Reference SSM61977

Models Range Rover (All New) / L405

Title L405 Side Step Fitment Issues

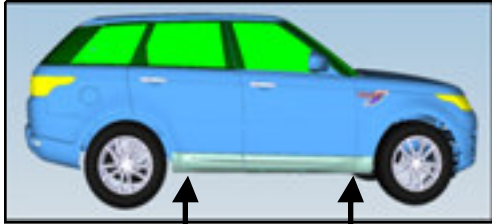
Content The current hole sizes in the body structure are undersized, preventing the bolts from fitting. This situation will be rectified and a clear VIN will be issued on a follow up SSM once introduced.

The 8 off bosses in the body structure need to be drilled out with a 9.3mm cobalt drill and then tapped out with an M10 tap. Please use a suitable lubricant whilst tapping out the bosses.

VIEW ON ARROW A

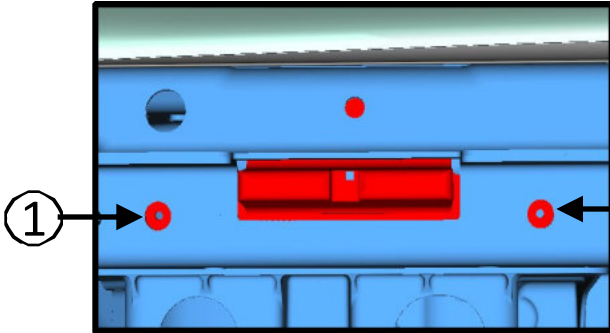
On all L405 vehicles built to date the thread forming bolts will not fit into the 8 off bosses (4 per side) in the body structure.

1. INCREASE EXISTING HOLES (1-4) TO $\varnothing 9.3\text{mm}$.
2. TAP HOLES USING M10 PLUG TAP.
